REMARKS/ARGUMENTS

Appl. No. 10/521,890

Amdt. dated May 9, 2007

Reply to office action of February 9, 2007

Annotated Sheet

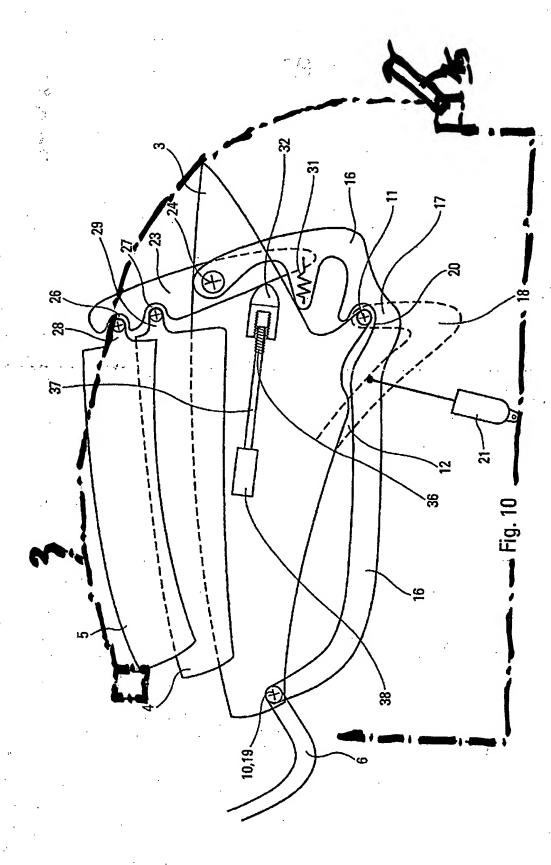
The drawings were objected to under 37 CFR 1.83(a) as failing to show that the folding roof at least partially projects out of the boot, as set forth in claim 1 of the present application.

Attached is an annotated or corrected drawing sheet as well as a replacement sheet for figure 10. Assignee has amended the drawing to show that the folding roof (3, 4, 5) at least partially projects out of the boot. Assignee has added the rear boot 2 that corresponds to the inner line of the boot hood 15 in its closed position, as shown on figure 3. In the closed position of the boot hood 15, its inner limit merges with the outer limit of the boot 2.

No new matter has been added to the drawings. The boot hood 15, when opened, is also shown in figure 2. On the amended figure 10, Assignee has further reproduced the lower limit of the boot shown on figure 3. Assignee has mainly superimposed on initial figure 10 the position of elements already shown in figure 3.
